2025 SANITARY SURVEY REPORT

Rosa Joint Ventures Water System NM3500324

Prepared by: Gordon Miller— Compliance Officer
New Mexico Environment Department
1800 E. 30th Street, Suite B
Farmington, NM 87401

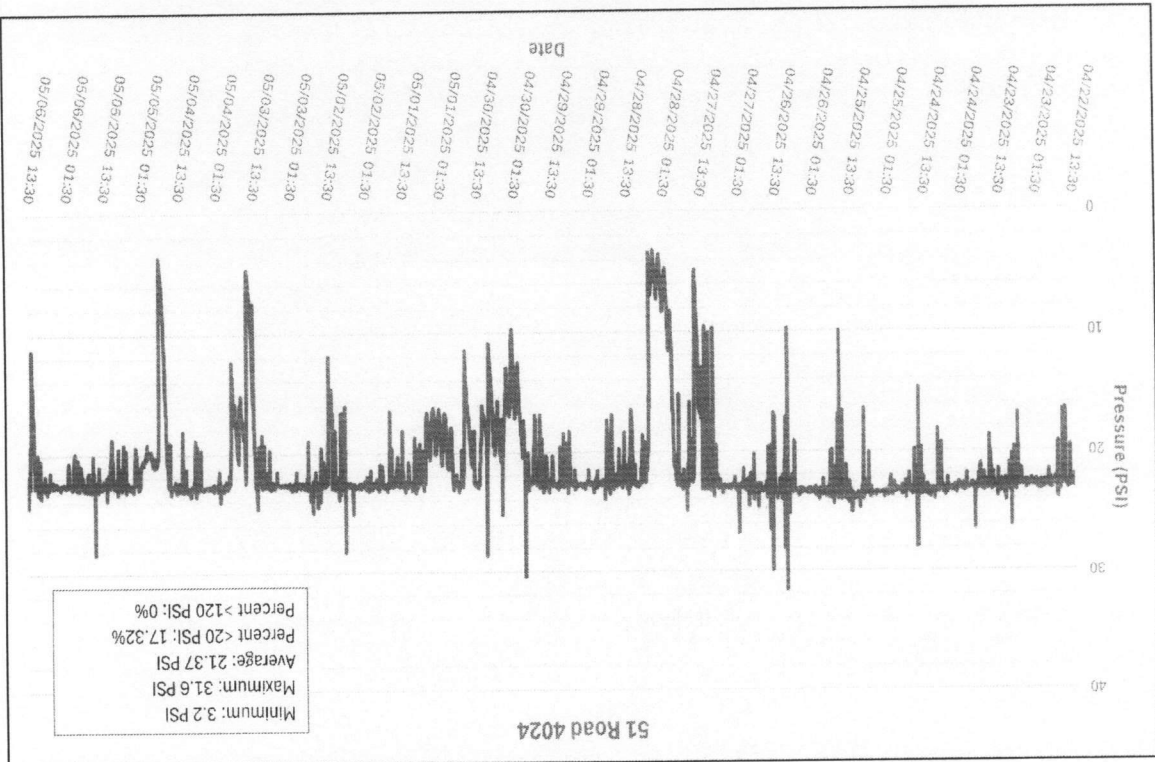
4. **Significant Deficiency Code: 006P – Inadequate pressure in distribution.**

Significant Deficiency Description: Pressure data measured between April 22, 2025 and May 6, 2025 indicate that pressure in the Rosa Meadows side of distribution is inadequate. A summary of pressure data measured over the approximately two (2) week period of time is shown in table below:

Over an approximately two (2) week period of time collecting a data point every five (5) minutes, 22.37 percent and 17.32 percent of measurements were under twenty (20) psi pressure in the Rosa Meadows side of distribution. Minimums measured at the respective locations were 1.38 PSI and 3.20 PSI, far below what is considered adequate pressure in a Public Water System distribution system. Averages of 19.80 PSI and 21.37 PSI respectively indicate that typical pressure is on the low end of what is considered adequate. Graphs of the entire data set collected can be seen in the Field Analysis section of this sanitary survey report.

Lack of storage facility water level indicators, manual operation of well and booster pumps, and relatively low production rates from the wells contribute to frequent low pressures in distribution.

Required Corrective Action: The Rosa Joint Ventures Water System must submit documentation acceptable to WPCFB indicating that adequate pressure is regularly being provided in distribution.

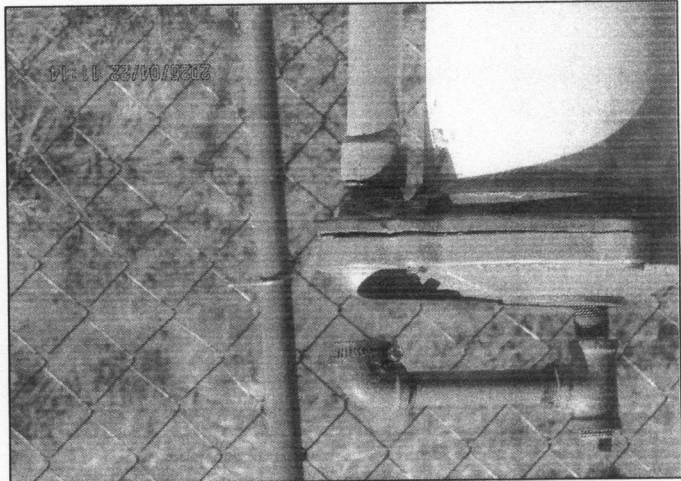
1. Significant Deficiency Code: 001L – Well head not properly sealed.

Significant Deficiency Description: On the day of the sanitary survey, it was observed that the electrical conduit was cracked and the sanitary well seal on the Meadow Well (#00324001) did not form a complete seal. The sanitary well seal appeared to have been sealed with caulk at one point, but the seal failed. An improperly sealed well head can allow non-potable water, insects, or vermin into the well and potentially contaminate the well and aquifer.

Required Corrective Action: The Rosa Joint Ventures Water System must submit photographs acceptable to WPCFB indicating that the sanitary well seal for the Meadow Well is equipped with a gasket and all bolts are tightened forming a complete seal or that the well head has been otherwise appropriately sealed. The Rosa Joint Ventures Water System must also submit photographs acceptable to WPCFB indicating that the electrical conduit for the Meadow Well is completely sealed.

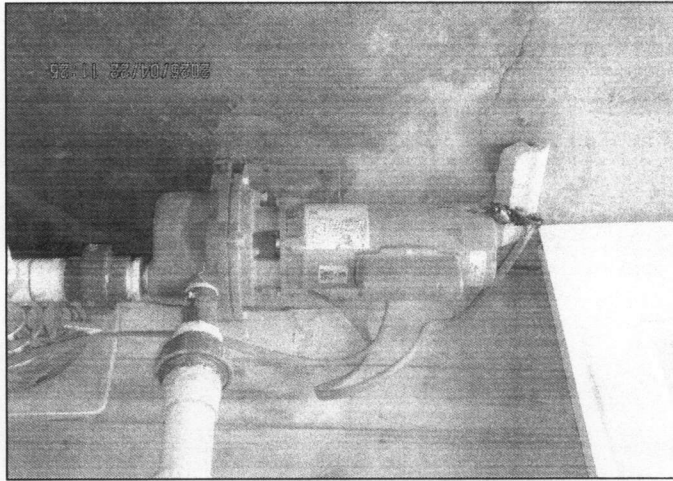
2. Significant Deficiency Code: 006L – Pump controls not secured from the elements.

Significant Deficiency Description: On the day of the sanitary survey, the wiring for the booster pump located in the Well House (#00324003) was observed to be exposed and lacking proper insulation. The system has a history of pump failures at this location and does not have a backup pump for redundancy. This pump is critical to maintaining adequate pressure in the Rosa Meadows side of distribution.

Required Corrective Action: The Rosa Joint Ventures Water System must submit a photograph acceptable to WPCFB indicating that the wiring for the booster pump in the Well House (#00324003) has been properly secured from the elements and that there is no exposed wiring.

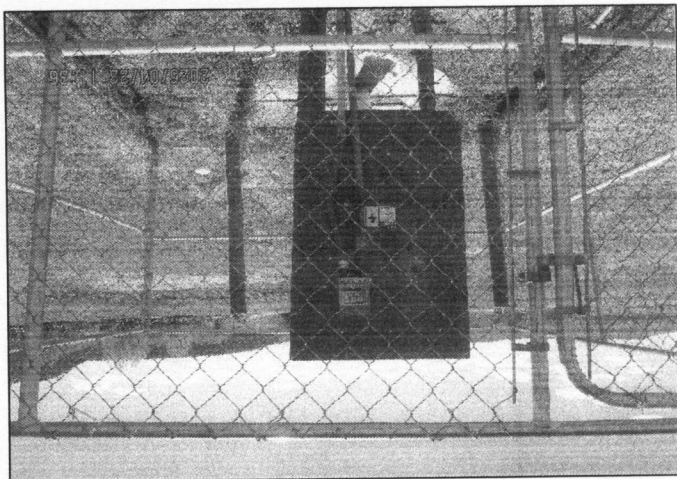
3. Significant Deficiency Code: 001D – Inoperable controls at source facility.

Significant Deficiency Description: On the day of the sanitary survey, it was observed that an electrical capacitor in the pump controls for the Nob Well (#00324004) had failed and the well was out of service.

Required Corrective Action: The Rosa Joint Ventures Water System must submit a photograph or other documentation acceptable to WPCCB indicating that the electrical capacitor has been replaced in the pump controls for the Nob Well (#00324004) and the well is operational.
